South Texas Project Electric Generating Station P.O. Box 289 Wadsworth, Texas 77483

U7-C-STP-NRC-100123

South Texas Project  
Units 3 and 4  
Docket Nos. 52-012 and 52-013  
Response to Requests for Additional Information

02.05.04-36

**Figure 2.5S.4-80 Dynamic Engineering Parameters for Backfill (85% Relative Density)**  
**Shear Modulus Parameter, K2**

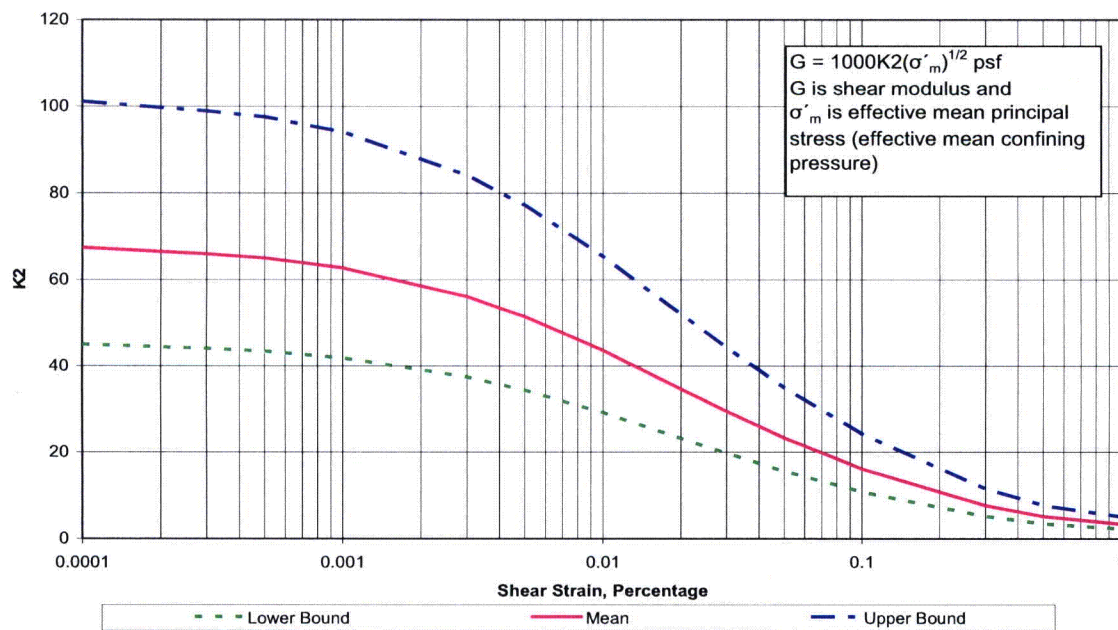
Table 3.0-11, Backfill under Category I Structures, provided in Supplement 1 to RAI 2.5.4-33, includes an ITAAC for shear wave velocity and the newly proposed ITAAC for lab testing of backfill from unidentified sources. Table 3.0-13, submitted in the response to RAI 2.5.4-30, contains the settlement ITAAC. All of these ITAAC lack specific acceptance criteria, as well as specificity in the other elements of the ITAAC. Please update these three ITAAC to reflect a clear demonstration that the assumptions in the safety analyses are verified consistent with requirement in 10 CFR 100.23. For the shear wave velocity ITAAC, please refer the NRC's August 7, 2009 letter to NEI regarding the NRC staff position and standard wording for backfill ITAAC under Category I structures.

Parameter	Acceptance Criteria
Grain Size Distribution	Well graded granular material Percent passing #200 sieve < 25 percent
Total Unit Weight	$\geq 120 \text{ lb/ft}^3$
Phi Angle	$\geq 30$ degrees
Shear Modulus Reduction	Within UB and LB in Figure 2.5S.4-80
Damping Ratio	Within UB and LB in Figure 2.5S.4-81

- 1) For parameter K2 see Figure 2.5S.4-80. K2 values are for relative density,  $D_r = 85\%$  (interpolated from  $D_r = 75\%$  and  $D_r = 90\%$ ) from Figure 5 of Report EERC 70-10, December 1970 by Seed and Idriss.
- 2) K2 values for Lower Bound are K2 values for Mean divided by 1.5.
- 3) K2 values for Upper Bound are K2 values for Mean multiplied by 1.5.
- 4) Damping values are from Figure 10 of Report EERC 70-10, December 1970 by Seed and Idriss. Note that Upper Bound damping values shall be used with Lower Bound Shear Modulus and Lower Bound damping values shall be used with Upper Bound Shear Modulus.
- 5) Damping values used in analysis shall not exceed 15% per SRP 3.7.2.
